PARTS & SERVICE NEWS

| REF NO. | AT03081 |

SUBJECT: INSTALLATION PROCEDURE OF ENGINE STARTABILITY IMPROVEMENT KIT AT LOW AMBIENT TEMPERATURE

PURPOSE: To introduce installation procedure for the newly developed parts kit to improve the engine starting performance under low ambient temperature environments for use on GD555-3 thru GD675-3 motor graders

Fig. 3

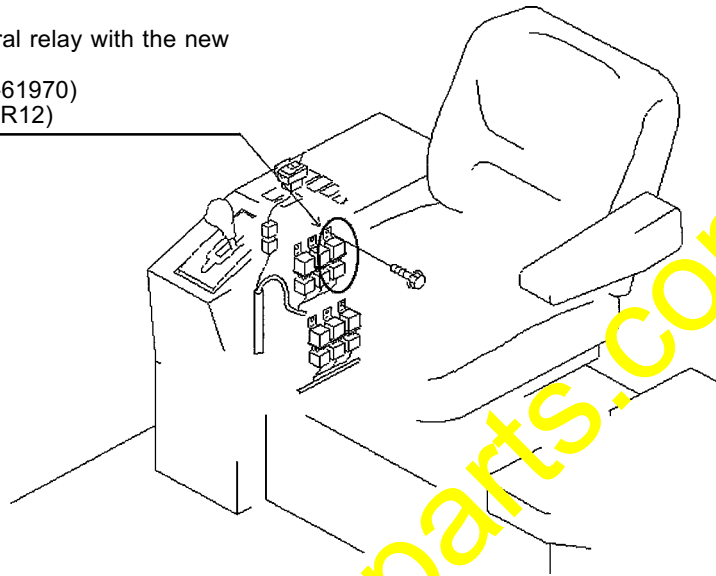
3) Changing the neutral relay (Refer to Fig. 3.)

Disconnect the connector No. BR12 and replace the neutral relay with the new relay. (The relay to be replaced is the one to which the connector No. BR12 is being connected.)

Leave the disconnected connector as it is.

※ Part No. of the new relay to install : 569-06-61970

Replace the neutral relay with the new relay.
(Part No. 569-06-61970)
(Connector No. BR12)

Fig. 4

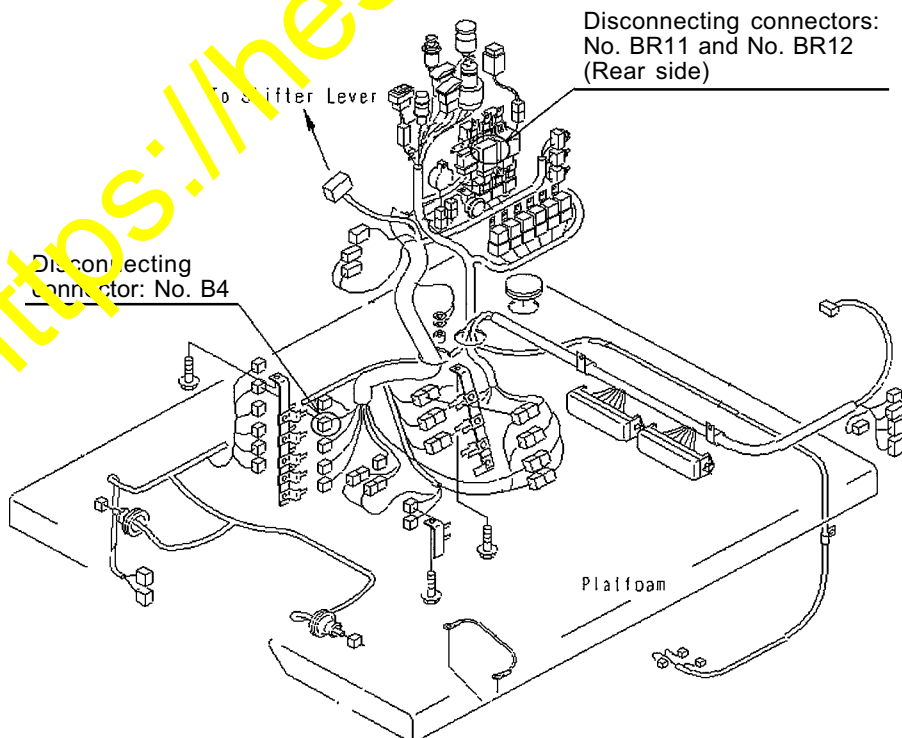
4) Disconnecting the harness (Refer to Fig. 4.)

Disconnect the connectors No. B4 and No. BR11 being positioned as per the drawing below.

(The connector No. BR12 has already been disconnected as per the above section 3).

Fig. 5

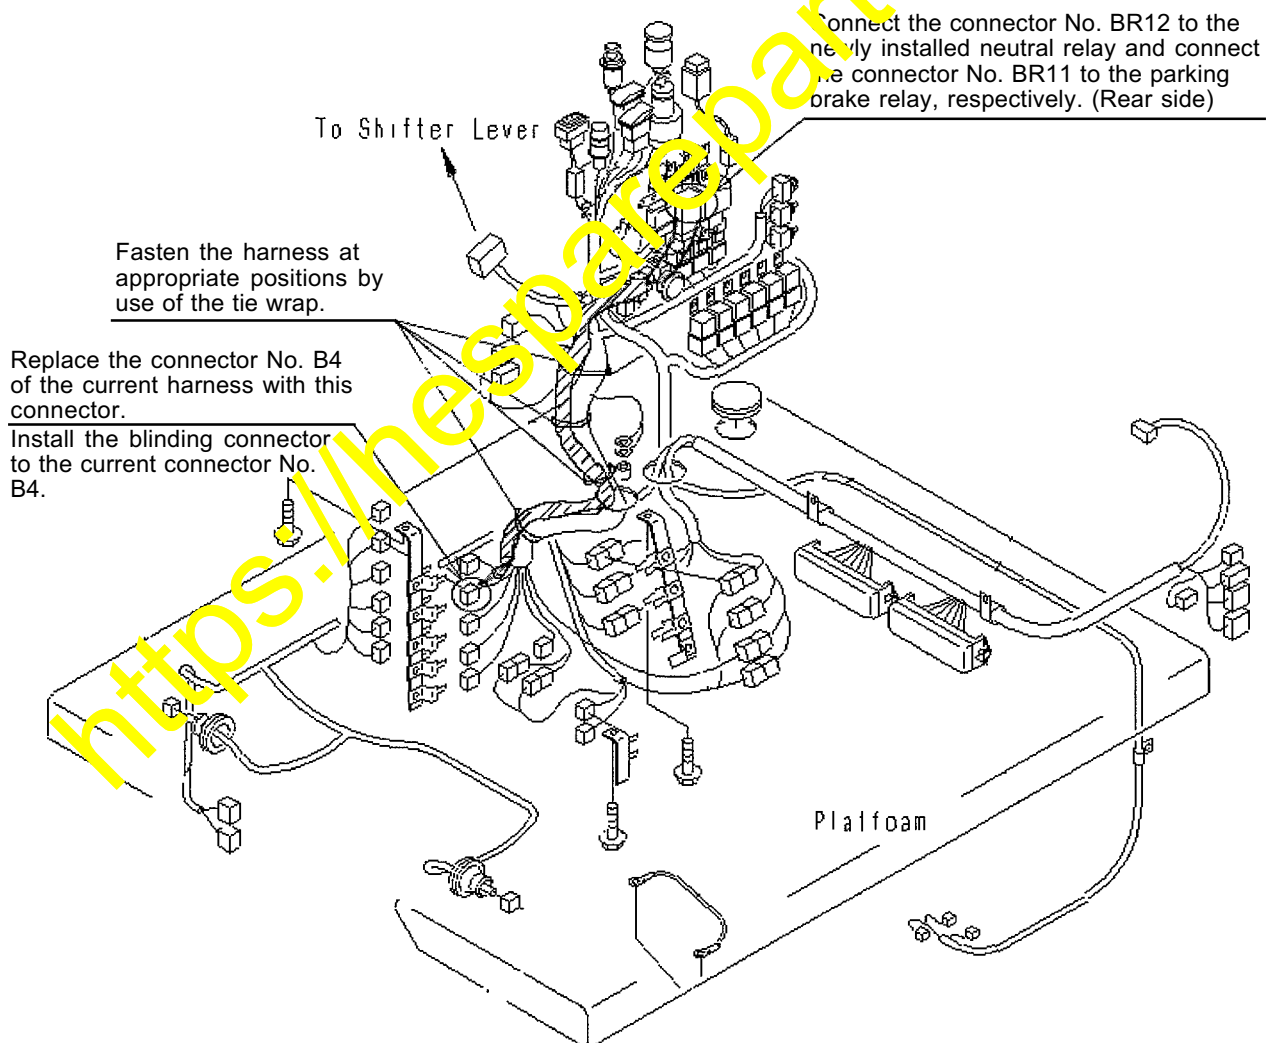
5) Installing the additional harness (RH console box) (Refer to Fig. 5.)

First, pass the connectors No. BR12 and No. BR11 of the new harness into the RH console box through the lower side of the operator's stand.

Connect these connectors (BR12 and BR11) of this new harness to the relay from which these connectors have been disconnected as per the above section 4).

After that, connect the connector No. B4 of the new harness to the corresponding connector (B4) which has been disconnected as per the above section 4) before fastening to the connector bracket.

※ Part No. of the installing additional harness : 23B-06-41640 (hatched section)

※ Blind plug for the current connector No. B4

Fig. 6

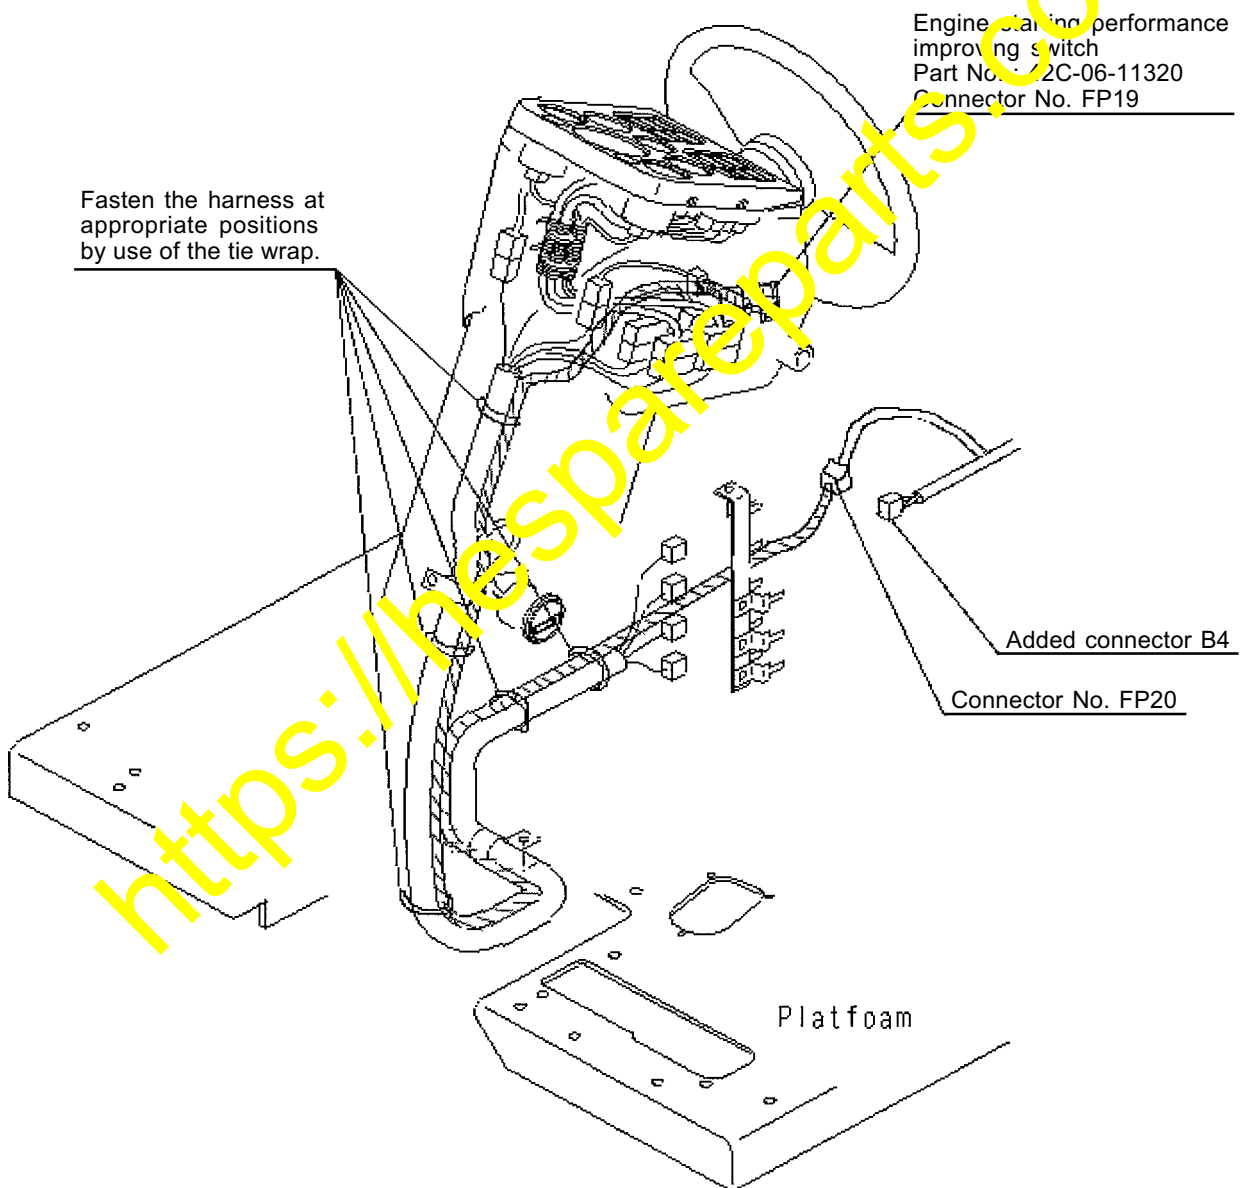
- 6) Installation of the harness and the switch (inside the steering wheel post)
(Refer to Fig. 6.)

Removing the blinding cap, install the new switch.

(Although there are two mounting holes, use the steering wheel side hole.)

Installing the harness to the switch (by the connector No. FP19), fasten the harness along the currently installed harness using the tie wrap.

※ Part No. of the harness to install : 23B-06-41650 (hatched section)

Connect the harness to the connector No. FP20 of the harness which has been installed as per the above section 5).

Fig. 7

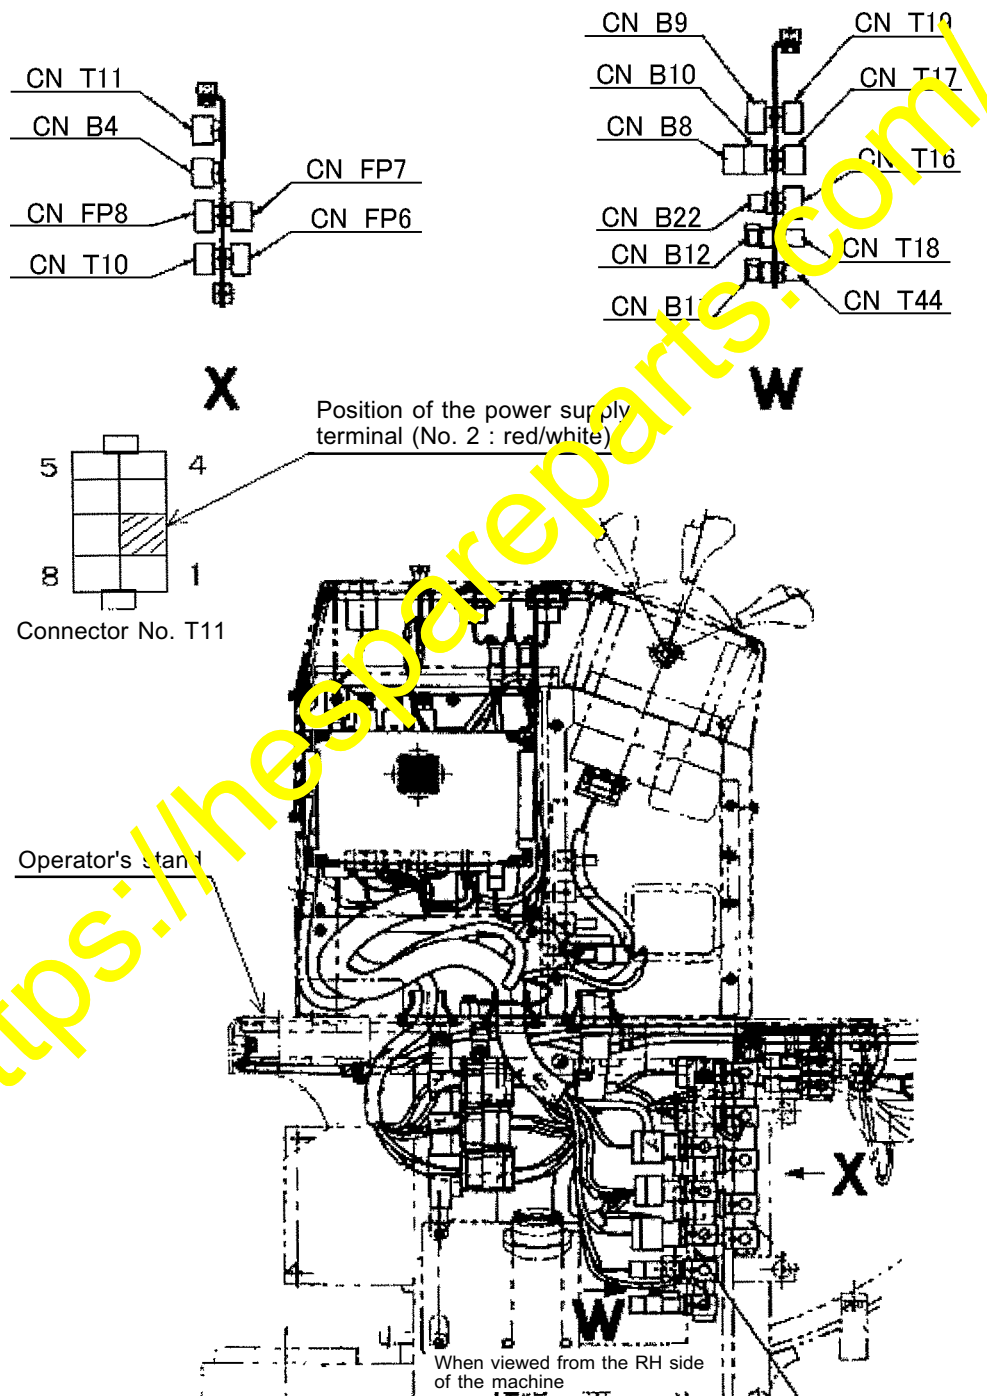
- 7) Connecting the power supply to the neutral relay (Refer to Fig. 7.)
 Connect the single lead (red/white) harness coming out from the new harness (23B-06-41640) to the No. 2 terminal of the connector No. T11 (red/white).
 (The connecting position can be optional.)
 Regarding the connecting method, adopt either soldering or caulking by use of crimp sleeve. (Regarding the using method of the crimp sleeve, refer to the Attached Sheet 1.)

Fig. 8

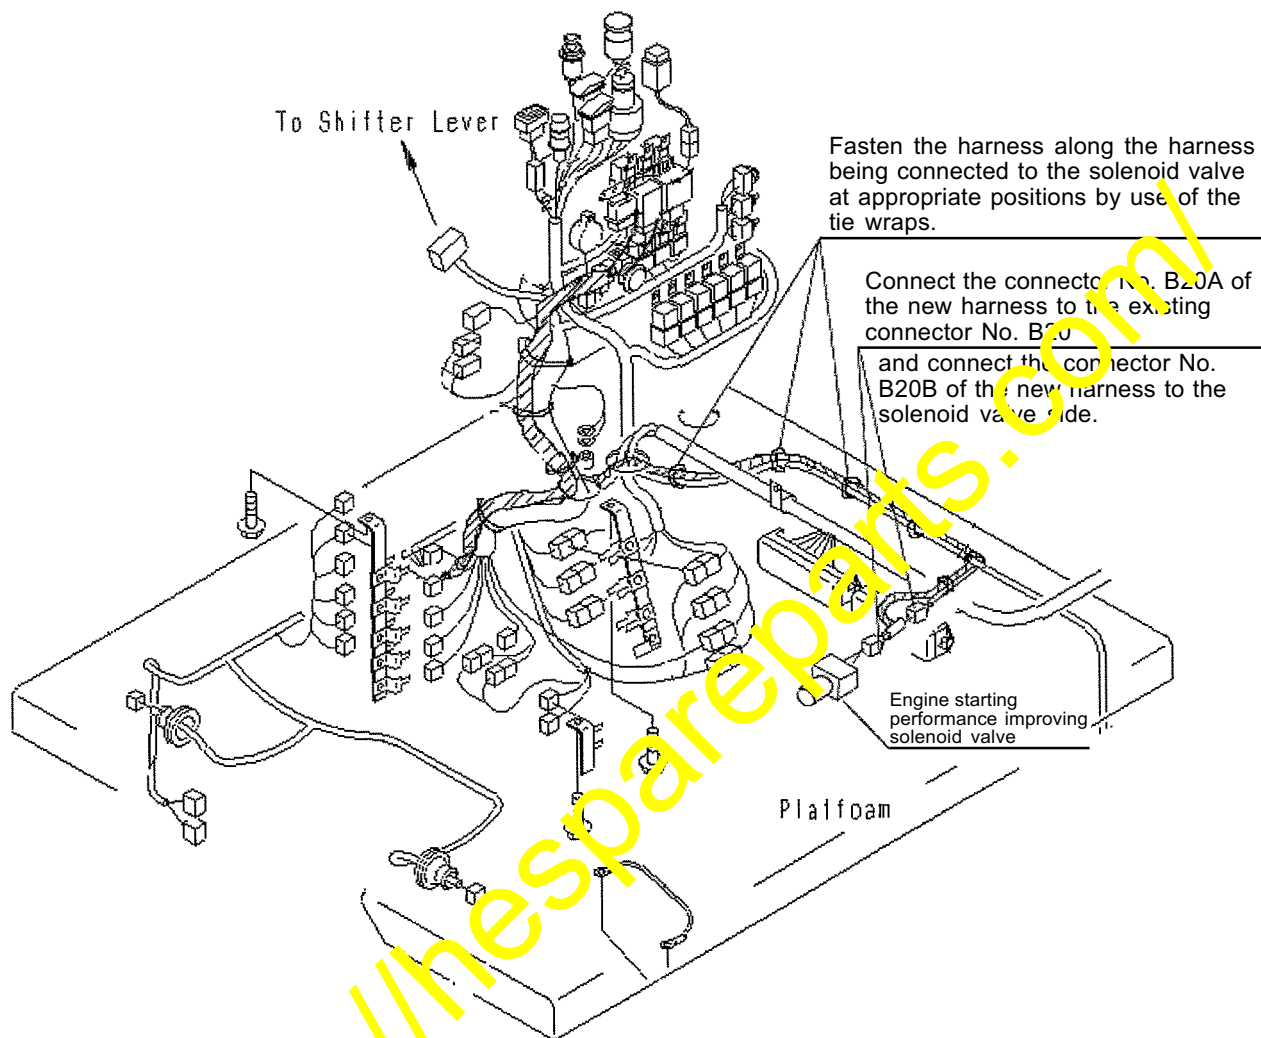
- 8) Connecting the solenoid valve (Refer to Fig. 8.)
Install the new harness as it connects both ends of the existing connector (B20) at the solenoid valve and the existing harness side.
